NUREG-1423
Volume 12

A Compilation of
Reports of
**The Advisory
Committee on
Nuclear Waste**

July 2001 - June 2002

**Report of the ACNW Working Group on Chemistry Issues
and Related NRC Staff Capability for the Proposed High-Level Waste
Repository at Yucca Mountain**

Figure 1. Waste form degradation model in TSPA-SR.

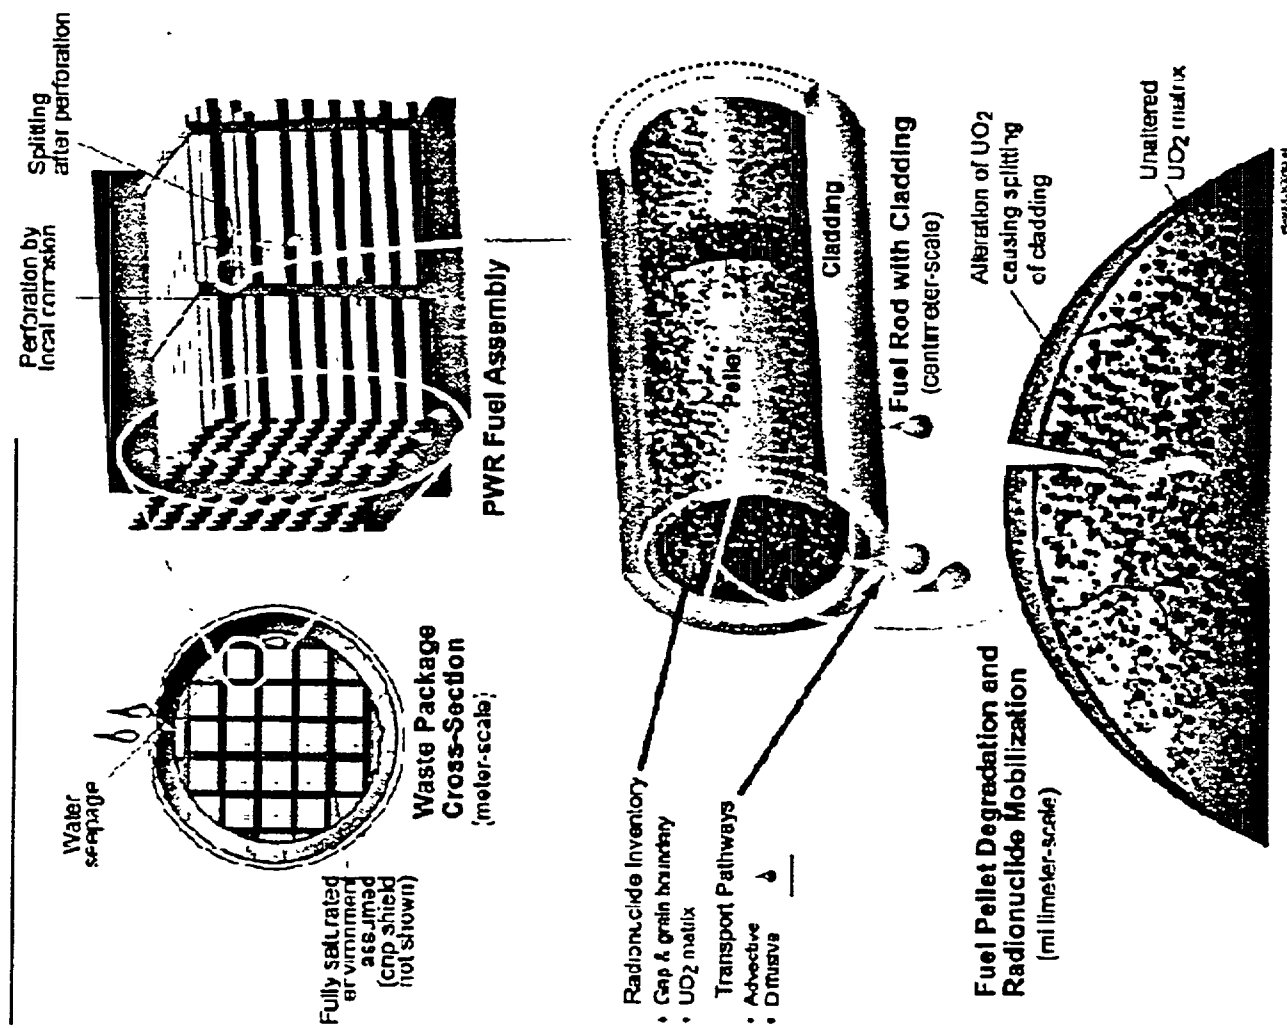
To mobilize radionuclides from the EBS, the TSPA-SR model uses both diffusive releases (via moisture films in the EBS) and advective releases (via flowing water).²⁵ The TSPA-SR results show that diffusion dominates the overall radionuclide releases from the repository even in the absence of flowing water. The model of diffusive transport of radionuclides out of the waste packages and through the invert is decoupled from the amount of liquid water available in the waste package. The water chemistry model is developed for a fully saturated waste package and is used to provide concentrations for the diffusion model. A zero-concentration boundary condition is assumed outside the waste package and at the interface between the invert and the unsaturated zone rock. These assumptions imply significant water is present, whereas a diffusion only model implies extremely limited amounts of water are present. Thus, the TSPA-SR employs conflicting physical and chemical processes and conditions to model the source term release. While this appears to be a very "conservative" approach, it is not clearly
